38 Chalcot Road

Delegated Report (Members' Briefing)		Analysis sheet		Expiry Date:		24/10/2014	
		N/A / attached		Consultation Expiry Date:		29/08/2014	
Officer				Application Number(s)			
Obote Hope				2014/5503/P			
Application Address				Drawing Numbers			
38 Chalcot Road London NW1 8LP				See decision notice			
PO 3/4	Area Team Signature	C&UD	Authorised Officer Signature				
Proposal(s)							
Installation of a new mansard roof extension, realignment of the window to the first floor of the rear extension, infill first floor window to the north elevation of the rear extension, provision of cast iron railings to the second floor terrace and installation of cast iron railings to the front of the property.							
Recommendation(s):		Grant Planning Permission					
Application Type:		Full Planning Permission					
Conditions:		Refer to Draft Decision Notice					
Informatives:							
Consultations							
Adjoining Occupiers:		No. notified	05	No. of responses	01	No. of objections	01

Installation of a new mansard roof extension, realignment of the window to the first floor of the rear extension, infill first floor window to the north elevation of the rear extension, provision of cast i

Existing dormer window along the row of terrace

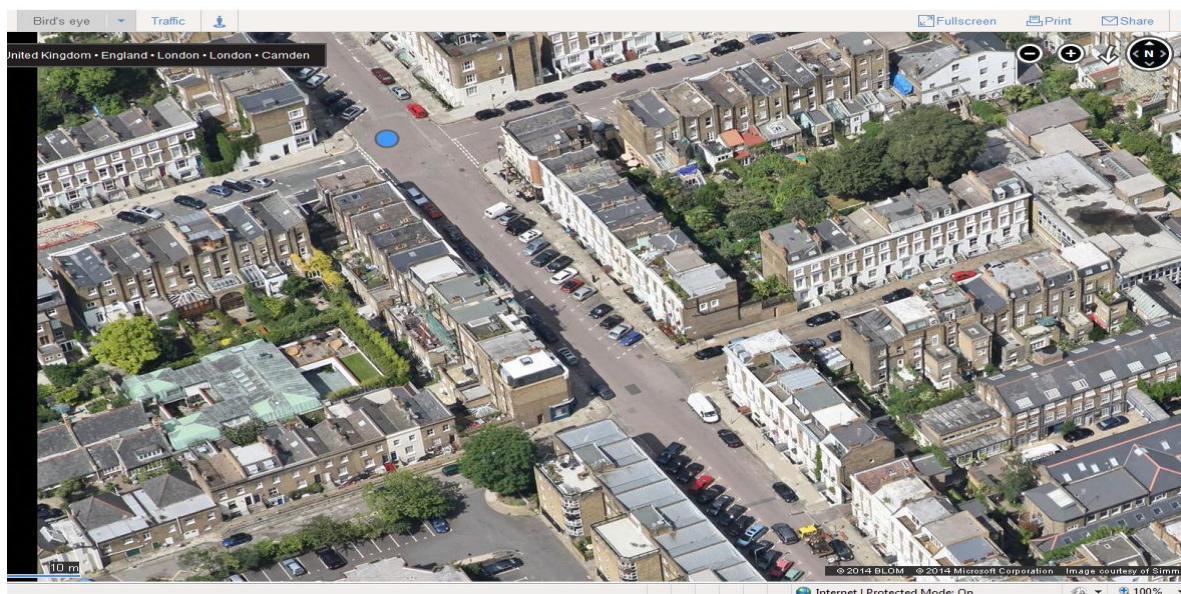
2.1 The proposal is for a traditional style mansard. At the front the lower slope would have an angle of 72.9° and be set behind the parapet. It would feature two dormer windows set 500mm below top of the front roofslope which would be subordinate to, and align with, the fenestration below. The butterfly profile of the existing rear elevation would be retained, with metal balustrading and inset French doors to create a terrace. The lower roofslopes would be clad in slate timber membrane and the windows would be identical as the existing being timber softwood and painted white to match the aesthetics of the host building, wider terrace and preserve and enhance the conservation area, all of which is consistent with the Primrose Hill Conservation Area Statement and Camden Planning Guidance.

Aerial view of the mansard roof extension within close proximity of the proposed site

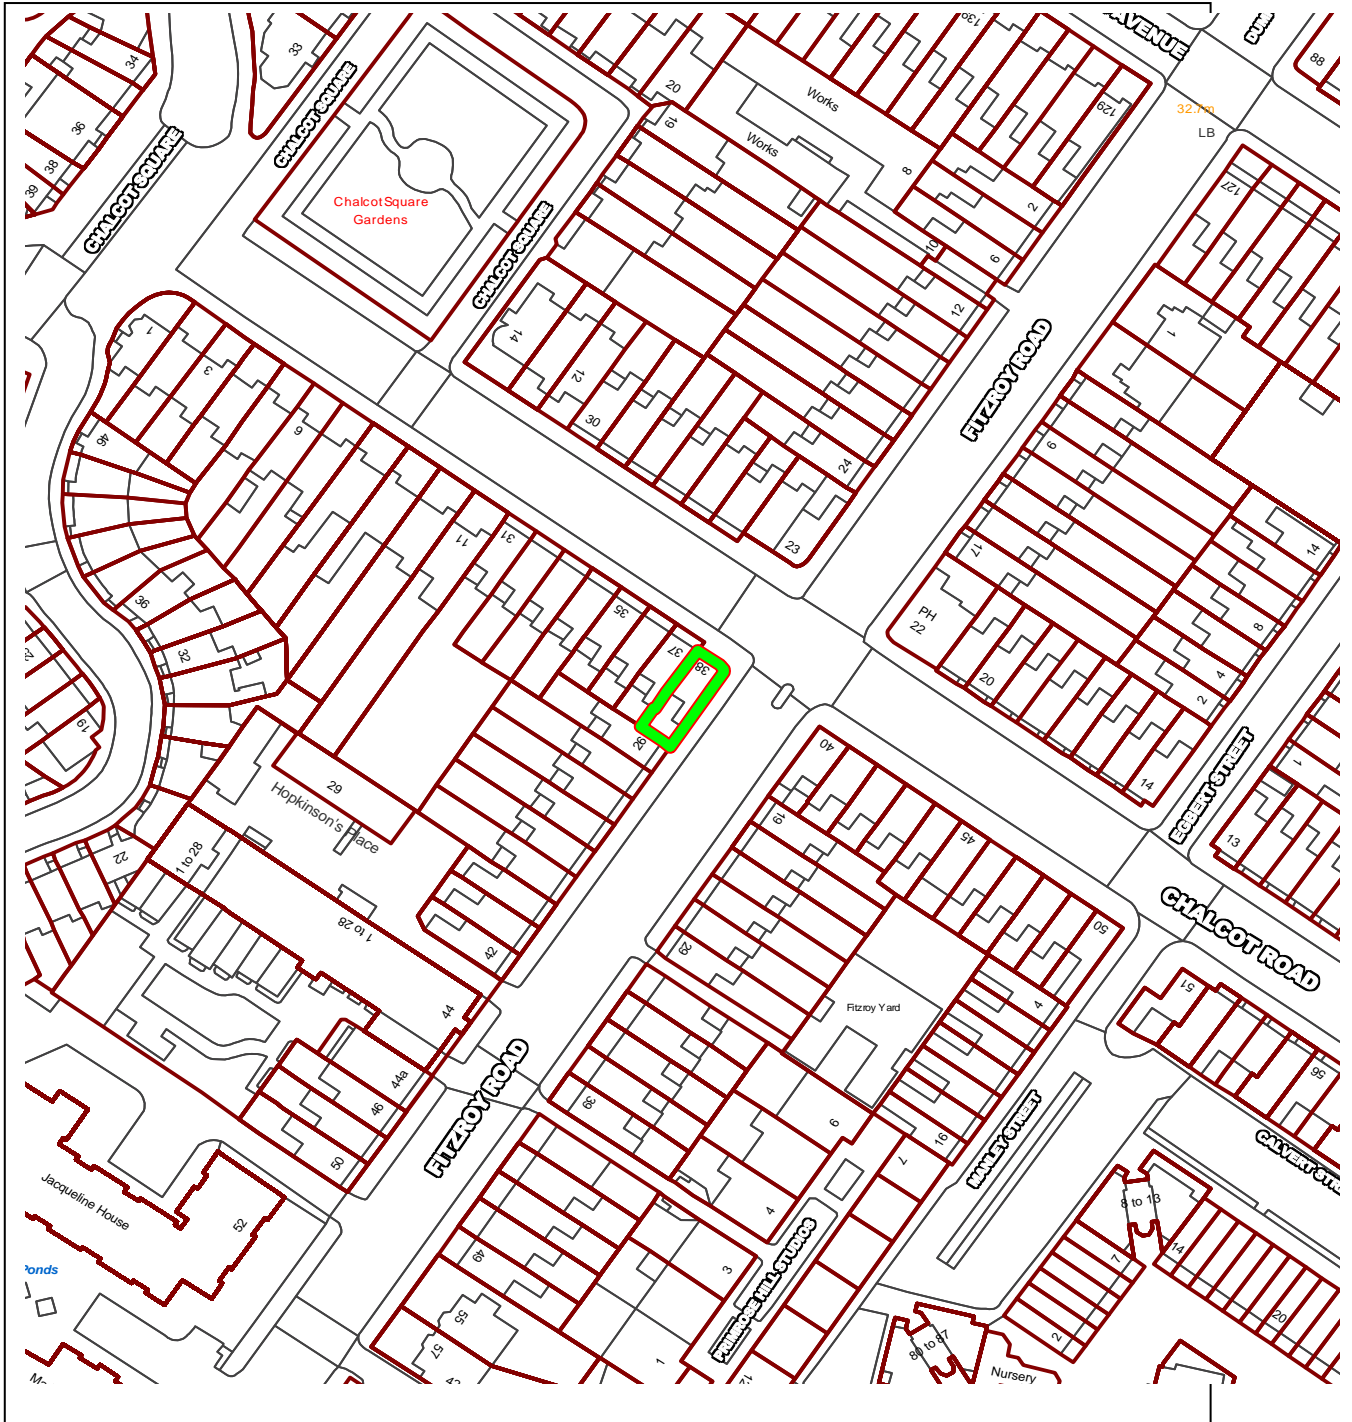
2.2 Many properties in Chalcot Road have mansards, some are historic and some are contrary to current planning guidance. There are four in the terrace of which the application site forms a part, nos 31, 32, 34 and the neighbouring property 37 Chalcot Road. There are also roof extensions to the majority of properties in the block opposite, and in the two blocks immediately to the west. In fact the only terrace which has a uniform roofscape is 51-66 Chalcot Road. The design in terms of its height, position and scale would be similar to the neighbouring property no 37 and as such would be difficult to refuse in terms of its design and location considering the amount of similar development in the street.
